Access Compliance Report

Public Rights-of-Way

(Curb Ramps)

Intersection ID: 42670	Main Street: WALLACE_CABIN_DR	Cross Street: WALLACE_CREEK_LN	Location: SW
ADA ID: 413115E79BEC	Ramp Type: PerpDiag	Initial Pass/Fail: Fail	Overall Compliance: No
			Severity Score: 21.25

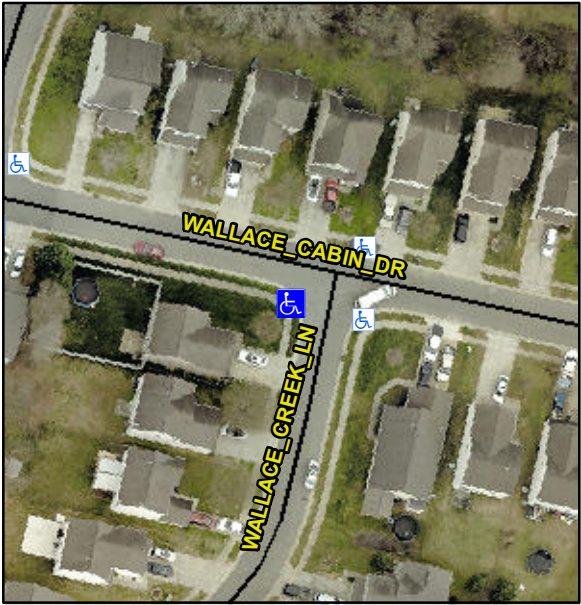
Codes/Mitigation Info/Possible Solution		Field Measurements/Component Compliance			
	Possible Solutions:				
	Remove & Replace Curb Ramp With Two New Directional Ramps or Equivalent.				
	Surveyor Notes:				
	N/A				
	PROW/ADA:				
	R304.5.1, R304.2.2				
	Street 1 Name	WALLACE CREEK LN			
	Stop Condition-Street 2	StopSign			
	Street 2 Name	WALLACE CABIN DR			
	Stop Condition-Street 1	None			
	Total Cost:	\$ 3200.00			
Compliance	Description	Data	Compliance	Description	Data
N/A	Ramp Length (in)	49.5	No	Ramp Slope (%)	10.8
No	Ramp Width (in)	46.5	Yes	Ramp XSlope (%)	1.2
N/A	Flare Type LT	N/A	N/A	Flare Type RT	N/A
N/A	Flare Slope LT (%)	N/A	N/A	Flare Slope RT (%)	N/A
N/A	Flare Traversable LT?	N/A	N/A	Flare Traversable RT?	N/A
N/A	Landing Length (in)	N/A	N/A	DWS Provided?	N/A
N/A	Landing Width (in)	N/A	N/A	DWS Contrast?	N/A
N/A	Landing Slope (%)	N/A	N/A	DWS Length (in)	N/A
N/A	Landing X Slope (%)	N/A	N/A	DWS Full Width?	N/A
